NCRE Additional Materials

September 17, 2018

As requested, enclosed please find additional materials which address questions and requests from the Planning Board in relation to the NCRE SEQR review. Since we have three municipalities reviewing at once, in cases where a question was asked by another municipality and the answer has already been shared to all, I did not duplicate it here. Included in this package you will find:

Traffic Study (appendix, page 3)

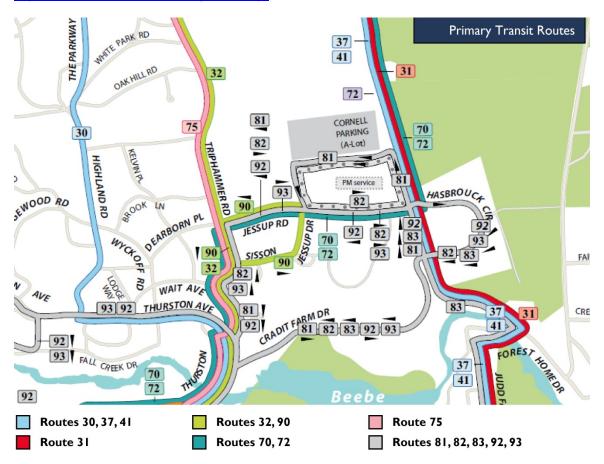
A legend for the bus route map on page 3 of the traffic report

The image shown on page 3 of the traffic study is taken directly from the TCAT bus route diagrams. Each colored line on the drawing represents a different route. Below is an image of the diagram with a key included. For further information on existing bus routes, an interactive system map can be found here: https://www.tcatbus.com/learn/system-map/
